APPENDIX E

AGENCY AND PUBLIC COORDINATION

DETAILED COMMENTS & COORDINATION

4.0 Comments and Coordination

Figure 8. Observed vs. modeled average daily link volumes

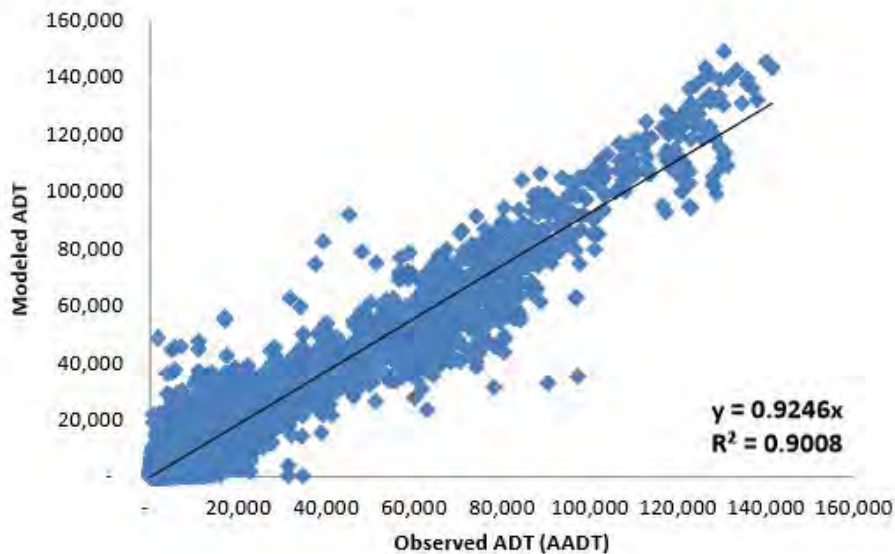
Comment 2: How was the data in Figure 2 determined? I'm sorry if this is a naive question, but it isn't immediately obvious, to us at least, how one would determine such a thing down to the number of vehicles. Just to be clear, no one is arguing that all the traffic originates or terminates in Riverwoods. Is it possible to get the exact same data for Lake Cook Road and Half Day Road?
